STAFF REPORT  
KETCHUM PLANNING AND ZONING COMMISSION  
REGULAR MEETING OF MARCH 14, 2023

**PROJECT:** The Perry Building

**APPLICATION TYPE:** Design Review (Application File No. P22-045C)  
Lot Consolidation—Preliminary Plat (Application File No. P22-045A)  
Condominium Subdivision – Preliminary Plat (Application File No. P22-045B)  
Variance Request (Application File No. P22-045D)

**REQUEST:** Final Design Review, Variance Request, Lot Consolidation Preliminary Plat, and Condominium Subdivision Preliminary Plat applications for the development of a new 53,756 gross-square-foot mixed-use building and parking garage.

Figure 4: Design Modifications at Street Corner (Project Plans Page 74)

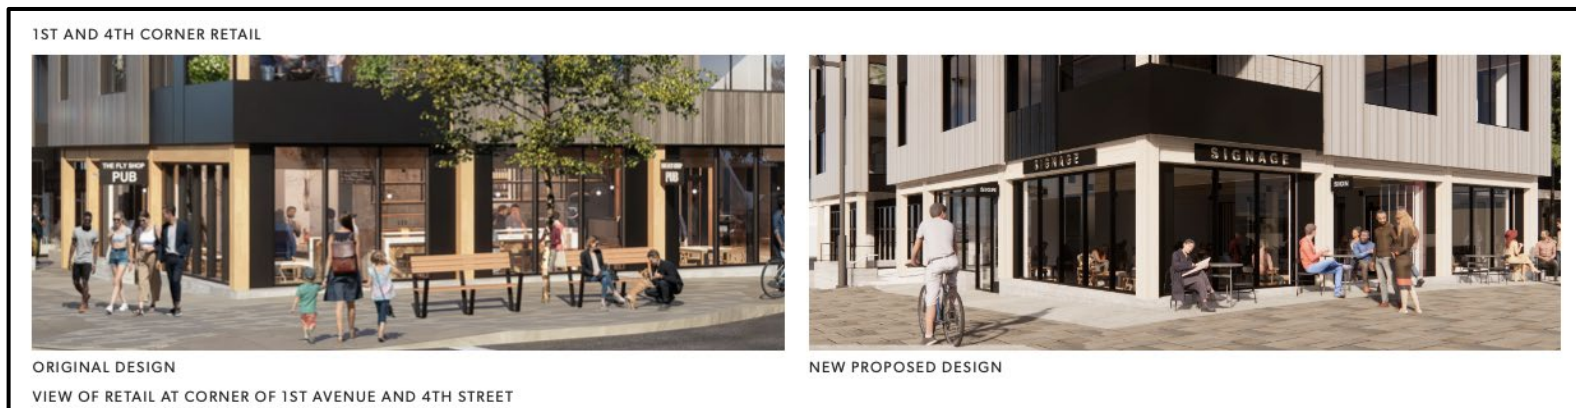
The applicant has addressed the design of the building corner on pages 73 and 74 of the project plans. The applicant's summary of the proposed design changes states:

Staff believes the applicant's design modifications to the building corner as shown in Figure 3 provide a human-scale, distinguish the ground-floor retail unit, and create a more pedestrian-friendly environment. Pursuant to KMC §17.96.070, "For nonresidential portions of buildings, front facades and facades fronting a pedestrian walkway shall be designed with ground floor storefront windows and doors with clear transparent glass." The ground-level design includes large storefront windows that provide views into the retail spaces from the sidewalk to create an engaging pedestrian environment. Warm wood beams frame the storefront windows along the street frontages. Projecting blade signs for the retail tenants extend down from these wood beams and are oriented perpendicular to pedestrian traffic to increase visibility. These design treatments highlight the retail unit at the building corner and animate the design of the ground level to create a more engaging, visually interesting, and vibrant pedestrian experience.

*We agree that activation of the intersection at 1<sup>st</sup> and 4<sup>th</sup> is a priority. The design includes large expanses of glazing on both frontages, providing openness and views of active commercial spaces from the street, while also providing ample daylighting and views from the interior. In order to provide accessible entrances to both retail and residential spaces in the building, it is necessary that the floor level at the building corner is slightly lower than the sidewalk grade. This difference flattens out as you move along the sidewalk, and is significantly less than the existing condition which provided a highly vibrant and active former use. Tall ceilings and tall operable glazed walls further enhance the connection between the interior and exterior, visually and spatially blending the activities. Additionally, the balcony railing above the corner retail*

*space has been re-proportioned giving additional clearance height to the retail below. The façade language on 1<sup>st</sup> Avenue has been revised to carry the warm, human-scaled wood beam expression consistently across retail storefronts, framing the large windows. Retail signage has been added at these been locations to further elevate the prominence of the retail at the corner. Note: Roof overhangs at this corner have also been adjusted in response to this recommendation. They have been adjusted to reduce the present of the residential levels above.*

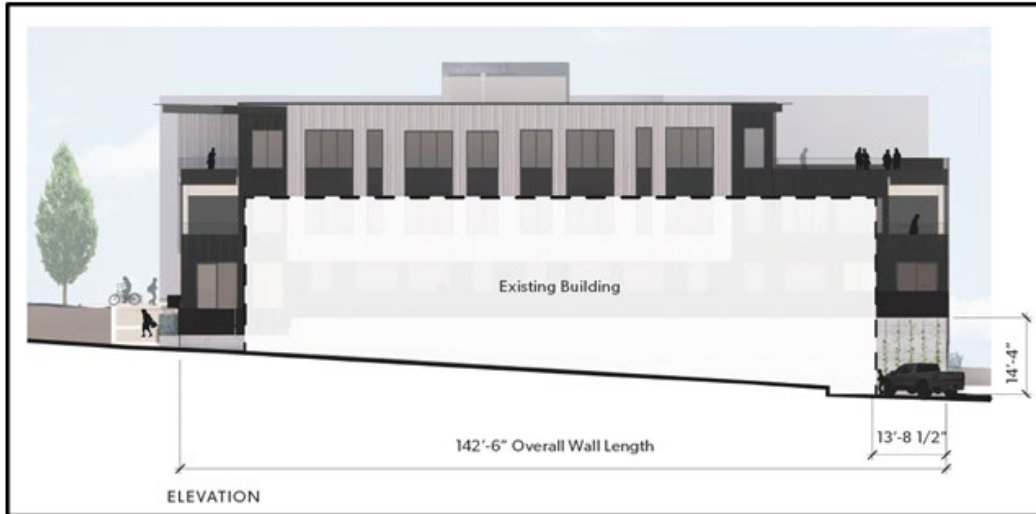
During their review of the Pre-Application, the Commission commented that the uniform roof plane along 1<sup>st</sup> Avenue diminished the effectiveness of the carve in building mass created by the courtyard. The Commission recommended that the applicant vary the design and height of the roof plane along 1<sup>st</sup> Avenue. The applicant's response to this comment is provided on pages 65 and 68 of the project plans. The applicant states:

*The setback of the floor and roof above the courtyard effectively provides relief to the overall massing of the building. The roof overhangs have been reduced significantly at both corners of the building, providing a more prominent pattern of offsets to the roofline. Viewed from various perspectives at street level a varied roofline is created reflective of the building's massing setbacks.*

Figure 7: Sunken Hole at Street Corner (Project Plans Page 45)

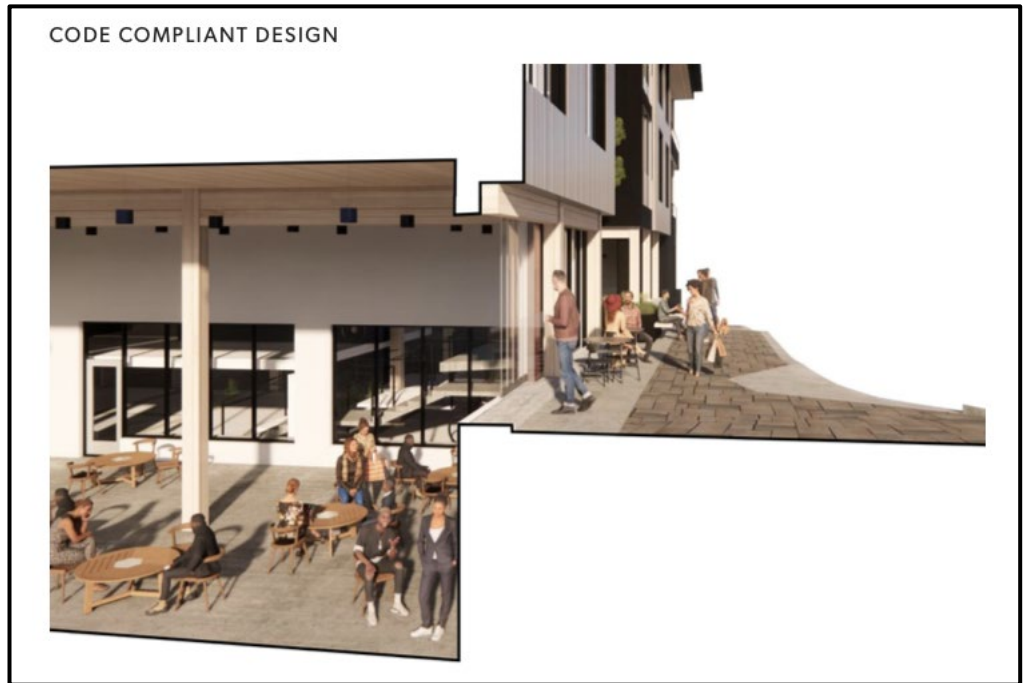
Additional excavation would be required to lower the garage to meet the definition of underground parking. Lowering the garage utilizing standard construction practices would significantly impact the building design resulting in a sunken hole at the street corner—the retail unit's ground-level finished floor would be 8 feet below sidewalk grade. Figure 6 provides a cross section that shows the retail unit in a sunken hole at the street corner and the building frontage along 1<sup>st</sup> Avenue (See Figure 7).

The applicant explains on page 46 of the project plans that, "the unique result of meeting this dimensional definition on this particular site with steep slopes on both frontages is that it pushes the underground parking significantly below (over 8.5') the adjacent sidewalk grade at the limited location of primary entrance relative to the corner intersection and the only flat area suited for accessing the first floor." Staff concurs with the applicant's argument and believes that the sunken hole would significantly diminish the quality of the pedestrian experience, activation of the ground floor, and vibrancy at the street corner.

## SITE PHOTOMETRICS GROUND PLANE

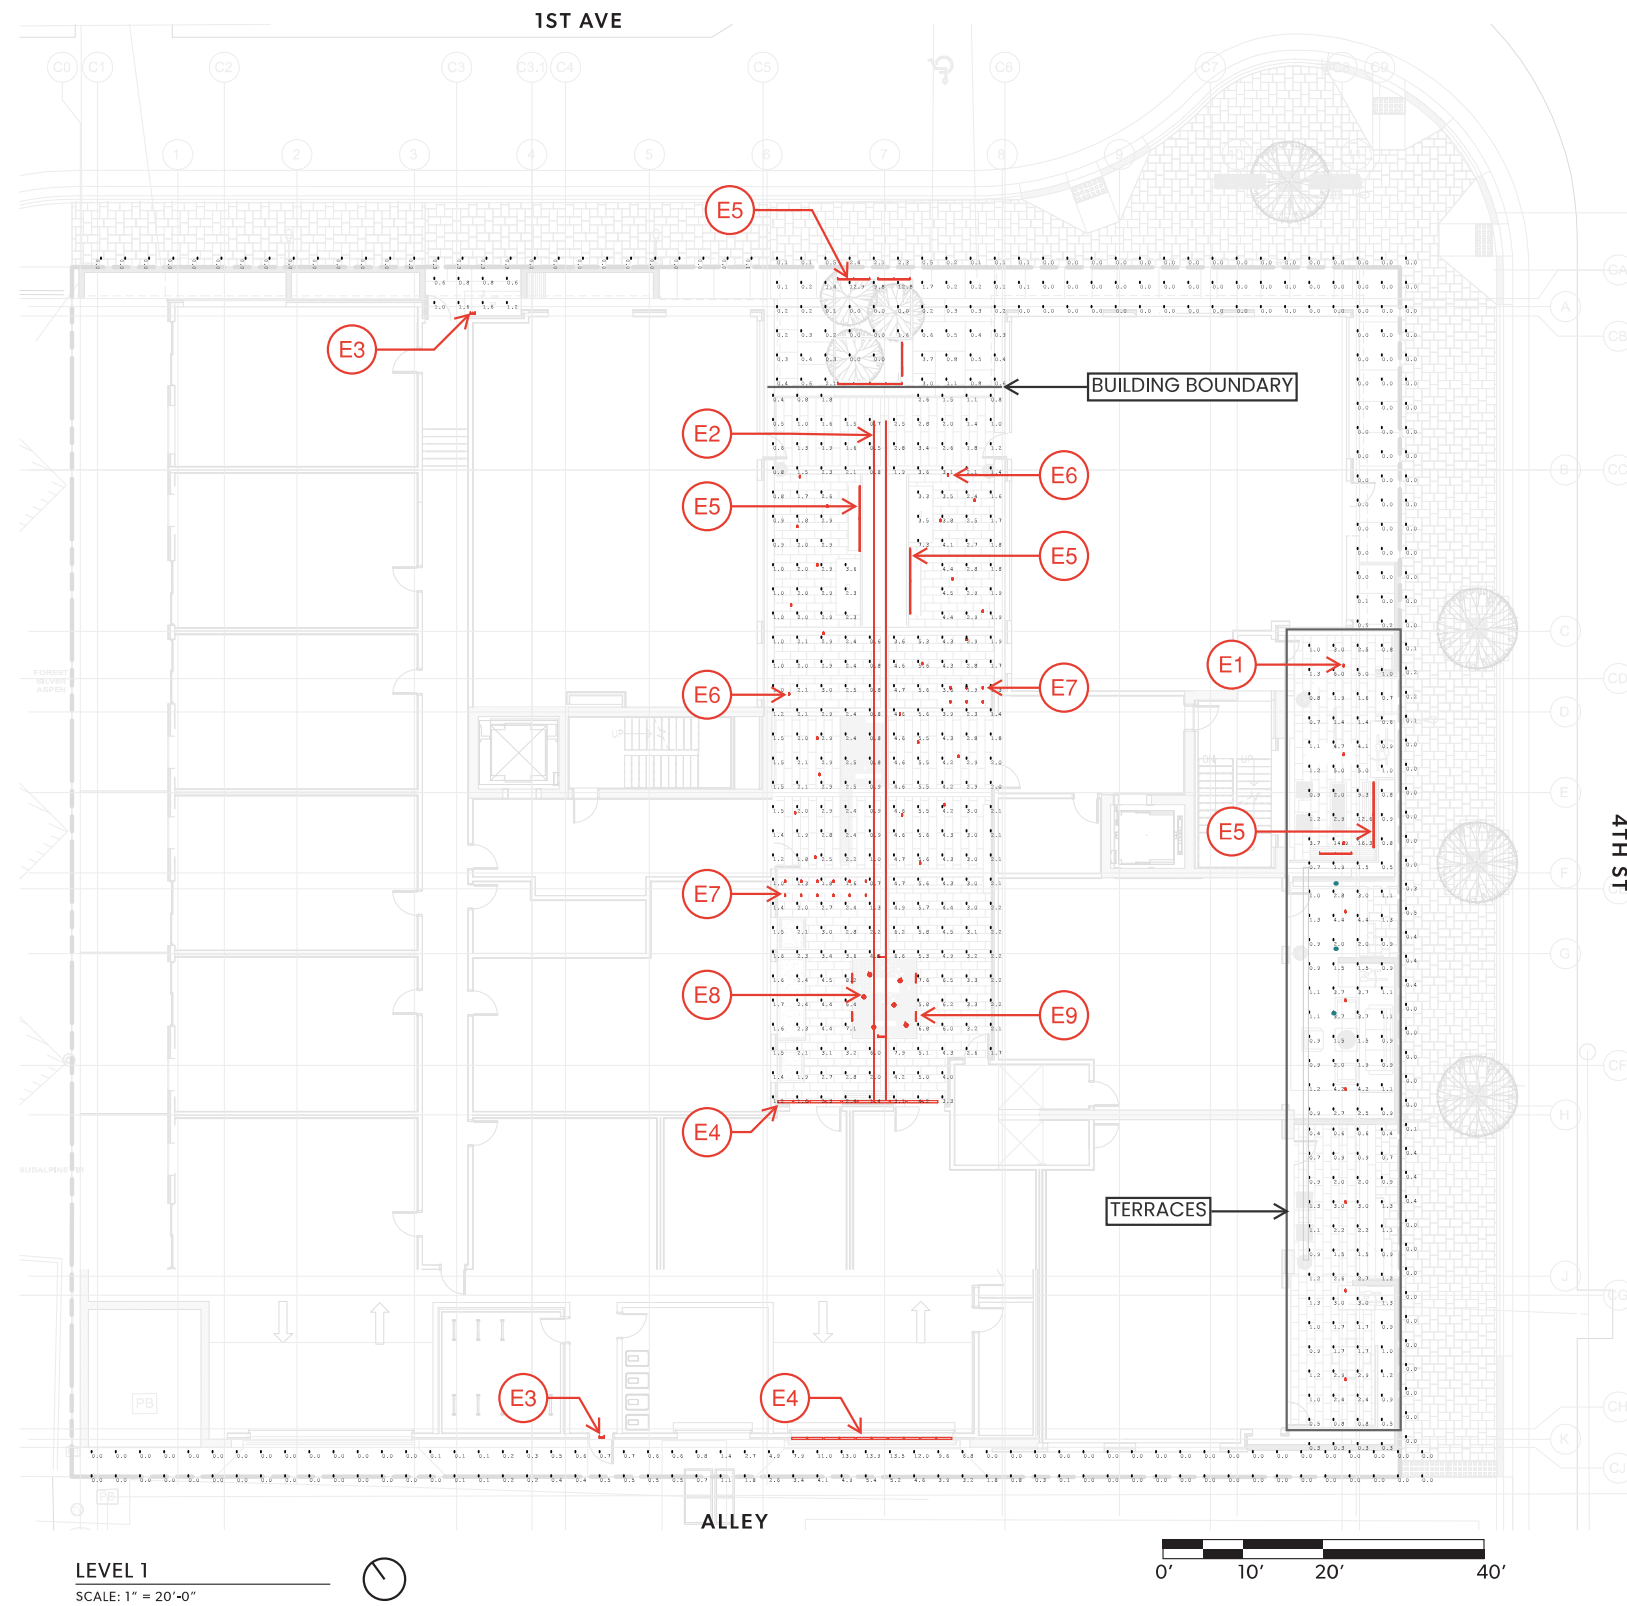
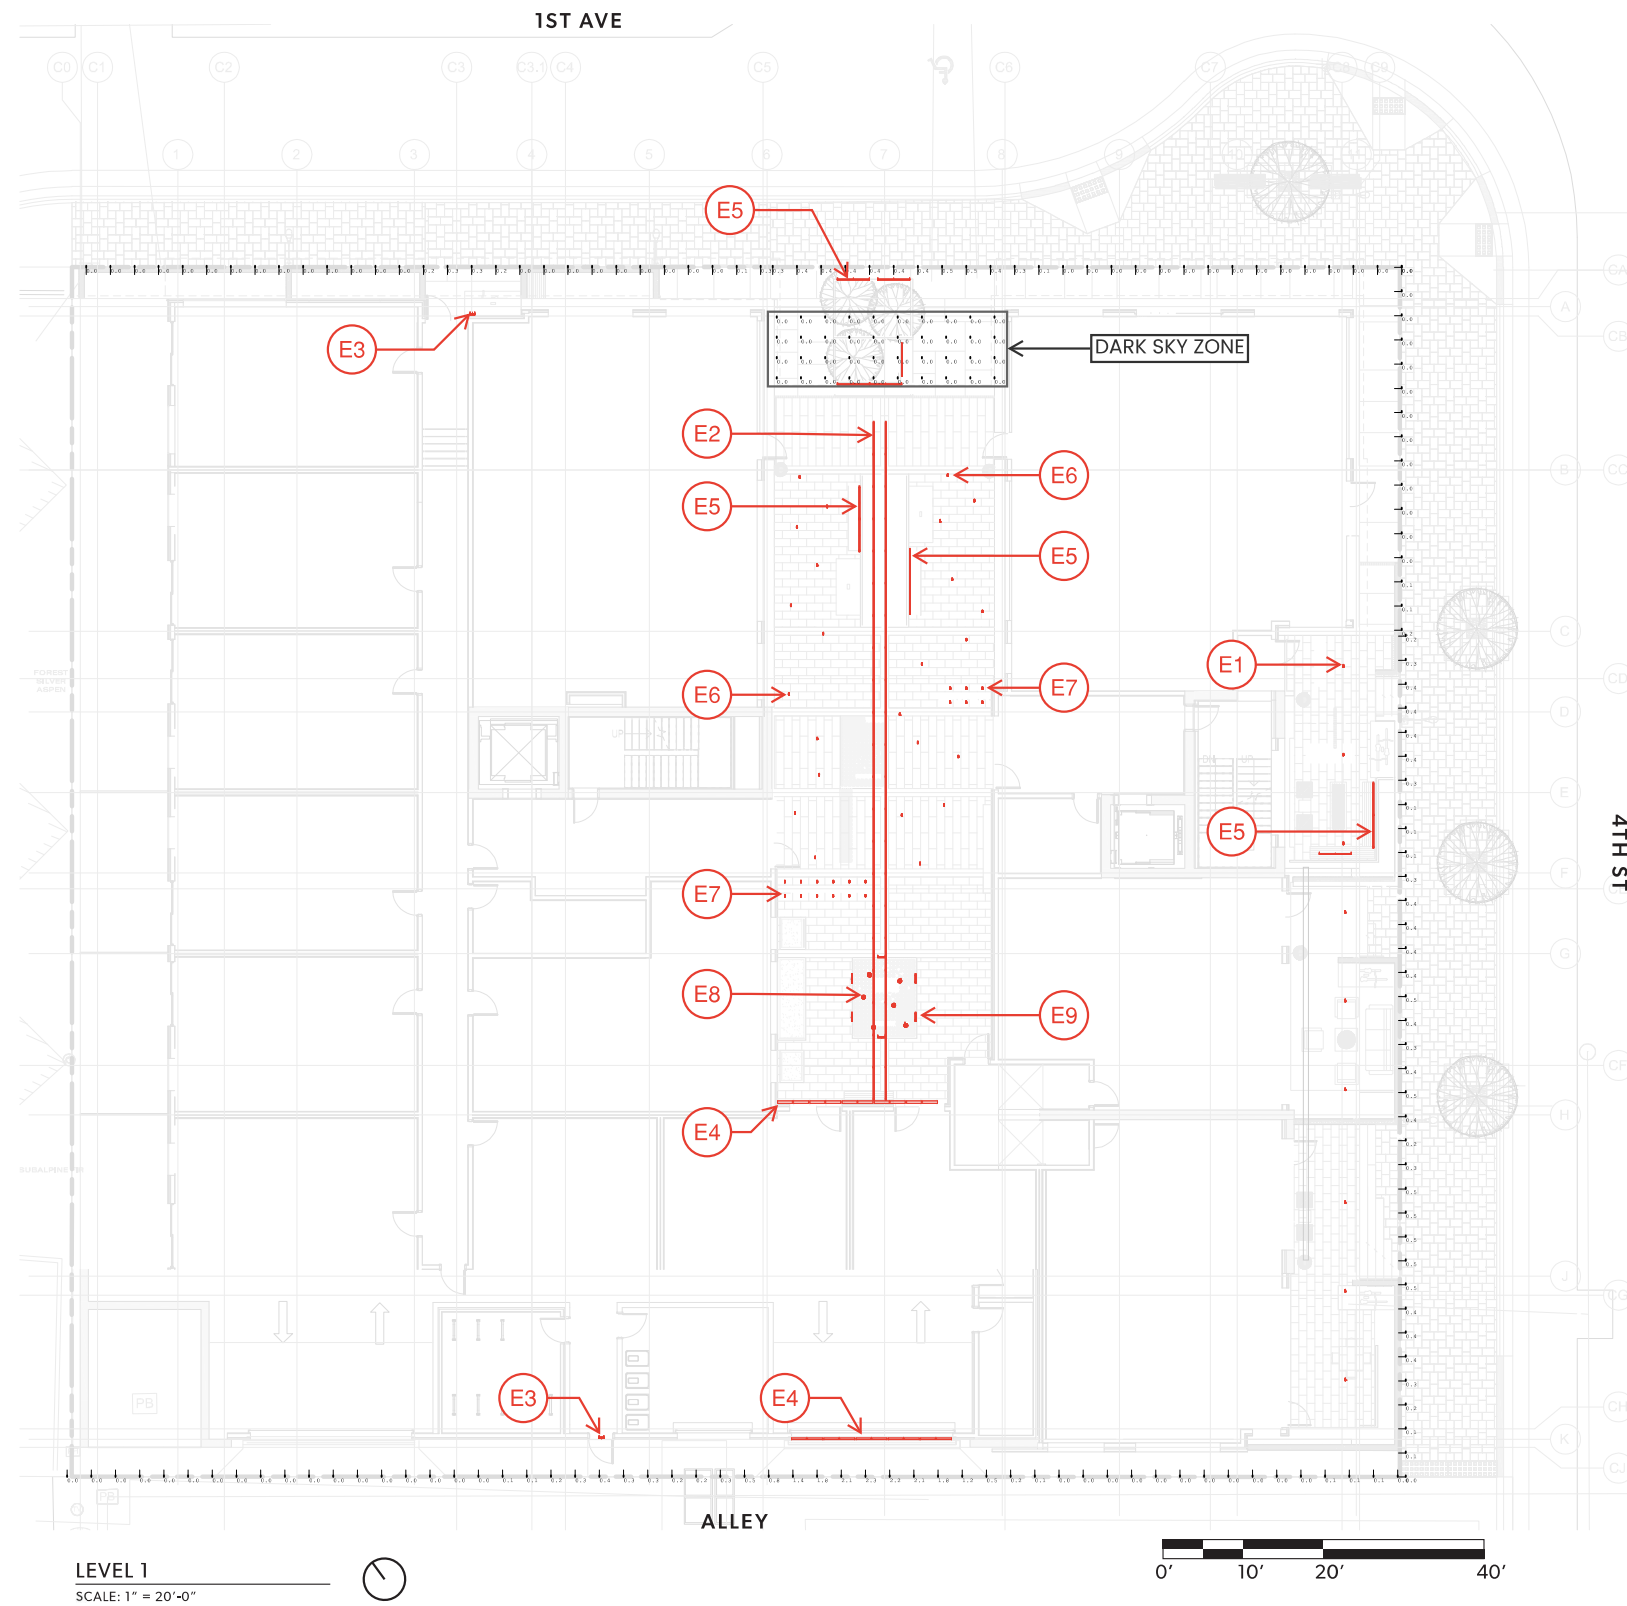
The applicant has provided two site photometric studies on pages 53 and 54 of the project plans. The photometric study on page 53 measures the light levels at the ground plane. The photometric study on page 54 measures the light levels 60 inches above the ground plane. Pursuant to KMC §17.132.030.B1, "all lighting emitting from any zoning lot shall not cause the light level along any property line, as measured at a height of 60 inches above grade in a plane at any angle of inclination, to exceed the limitations listed in figure 1, 'Light Trespass and Overlighting Matrix,' of this subsection." The light trespass and overlighting matrix does not provide maximum foot-candle limits for light trespass in the Community Core.

Recommended Condition of Approval No. 3: The applicant shall revise the garage door lighting and submit an updated photometric study that shows zero footcandles at the rear property line for Planning staff to verify that the fixture does not shine light directly onto the public right-of-way or cause glare along the alley prior to issuance of building permit.

Figure 5: Site Slopes & Cross Slopes (Project Plans Page 43)

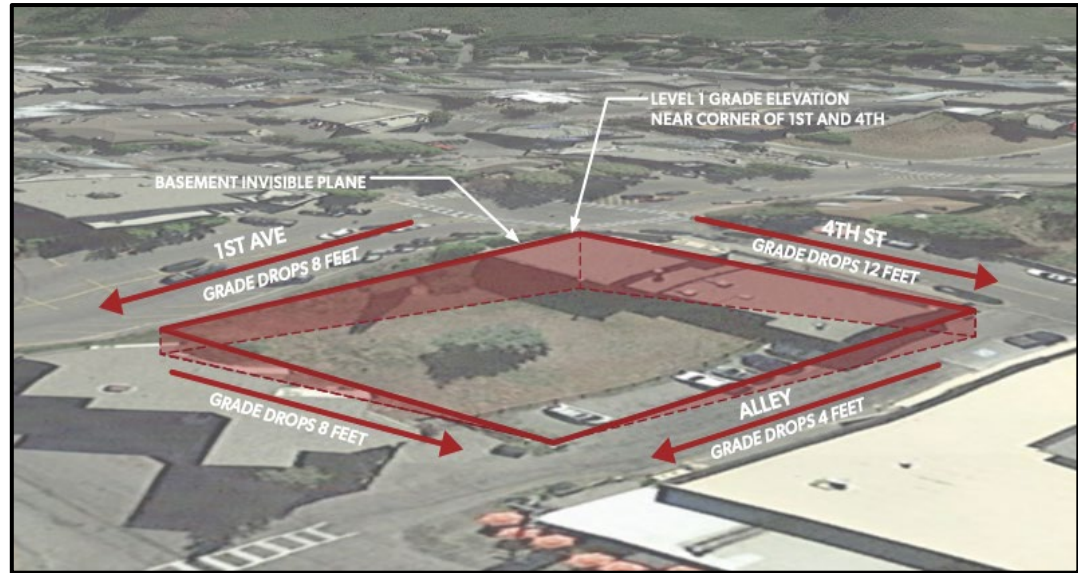
As shown on page 43 of the project plans, the subject property is characterized by topographical constraints with steep slopes along both street frontages (See Figure 5). From the street corner, the grade drops 8 feet down 1<sup>st</sup> Avenue and 12 feet down 4<sup>th</sup> Street. Along the alley property line, the grade drops 4 feet down from 4<sup>th</sup>

Figure 6: Parking Garage Ceiling Plane (Project Plans Page 46)

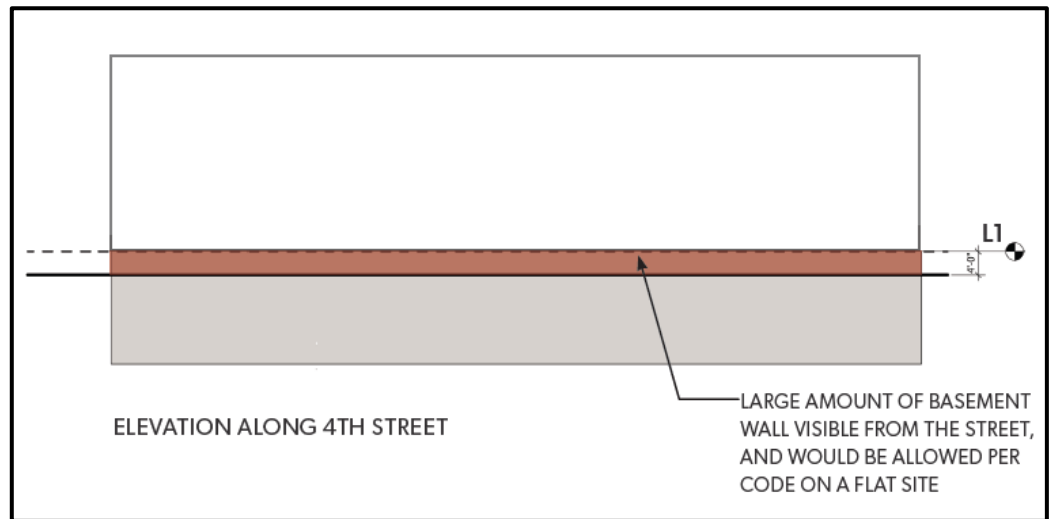
The zoning code allows a portion of the garage ceiling surface area to extend above finished grade, which increases visible building mass. The above-grade portions of the parking garage are exempt from the gross floor area calculation. On page 48 of the project plans, the applicant explains that, “On a typical flat or moderately sloped site the underground parking definition allows 4 feet (up to 33%) of the parking level be visible above the sidewalk grade and contribute to the bulk of structure which FAR restrictions are intended to limit.”
